## DEVELOPMENT APPLICATION ASSESSMENT REPORT

<b>Application Number:</b>	DA2024/0992
----------------------------	-------------

<b>Responsible Officer:</b>	Olivia Ramage
<b>Land to be developed (Address):</b>	Lot 27 DP 9500, 123 Waterview Street MONA VALE NSW 2103
<b>Proposed Development:</b>	Alterations and additions to a dwelling house
<b>Zoning:</b>	R2 Low Density Residential
<b>Development Permissible:</b>	Yes
<b>Existing Use Rights:</b>	No
<b>Consent Authority:</b>	Northern Beaches Council
<b>Land and Environment Court Action:</b>	No
<b>Applicant:</b>	Roman Marjanac

Figure 1 - Section plan showing extent of height variation

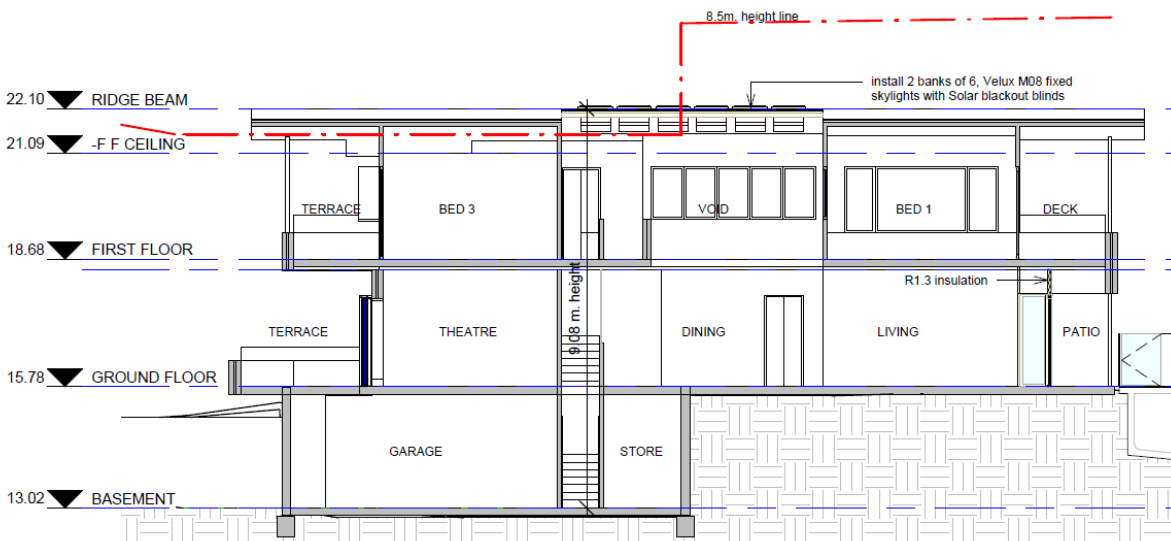
- The height breach is attributed to the replacement of part of the roof to the existing dwelling, whereby the overall height of the dwelling is not changing.
- The height variation arises due to the proposed new roof being sited above an existing excavated garage. As such, the height measurement is taken from the existing excavated ground level resulting in the variation.
- As the overall height of the existing dwelling is not changing, the development remains compatible with the height and scale of surrounding development.

It is acknowledged that the proposal involves the replacement of part of the existing roof and the height of the existing building is not changing. The height variation arises due to the existing excavated garage sited below the proposed replacement roof resulting in a lower ground level and increased height measurement. As the proposal does not increase the overall building height, the development remains compatible with the height and scale of surrounding development and is acceptable.

It is considered on balance, that having regard to the particular circumstances that the variation to Clause 4.3 Height of Buildings arises due to the existing excavated ground level and the proposal does not increase the height of the existing dwelling. As such, the proposed departure from the development standard is acceptable and it is reasonable that flexibility to the standard be applied.
